# Channel 7 Site 61 Mobbs Lane Epping

Preferred Project Report

**Section 75W Modification to Concept Plan MP 05\_0086  
and Schedule 3 Major Development SEPP Amendment**

**Figure 17. Oblique aerial view of proposed stepped buildings fronting park**  
 (Source: PTW Architects, not to scale)

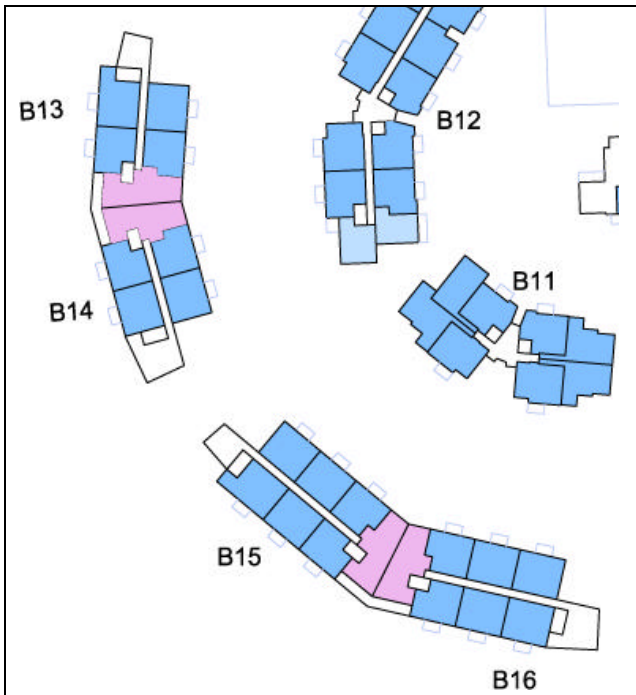
<p><b>Additional Information</b></p>	
<p><b>Additional Plans</b></p> <p>The building envelope plan is inconsistent with the common open space plan and is to be amended. A separate considered plan should be submitted illustrating all amendments to the Concept Plan.</p> <p>Building envelope plans are to be submitted that demonstrate the amendment to the built form in elevation/perspective view (e.g. the proposed amendment from 5-6 storeys to 6 storeys).</p>	<p>Additional Plans have been prepared by PTW Architects are submitted with this Preferred Project Report. Refer to <b>Appendix A</b>.</p> <p>Building Envelope Plan is illustrated with oblique aerial views in <b>Figure 4, Figure 6, Figure 8</b> and <b>Figure 10</b>. The plans illustrate the amendments to the building forms.</p> <p>It is noted that the proposed building forms comply with the 5-6 storey height controls in the approved building envelope plan. The proposal is consistent with the stepped built form arrangements. Refer to <b>Figure 17</b>.</p>
